- 1 Revised Table of Contents; Removed Notice To Bidders No. 20; Revised Bid Items; Revised Plan Sheet Nos. 8001 & 8002; Amendment EBSx Download Required.

PROJECT: NHPP-0007-01(103)/109671301 - Alcorn

Bridge Repair on US 72 over KCS Railroad (Bridge No. 64.4), known as Federal Aid Project No. NHPP-0007-01(103) / 109671301 in Alcorn County.

ADDENDUM

SHEET NO.
8001

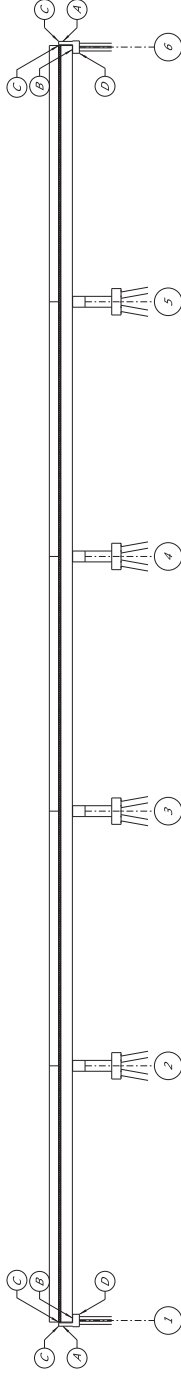
BRIDGE DIVISION		
REVISIONS		
DATE	SHEET NO.	BY
8/20/25	8002	SLD
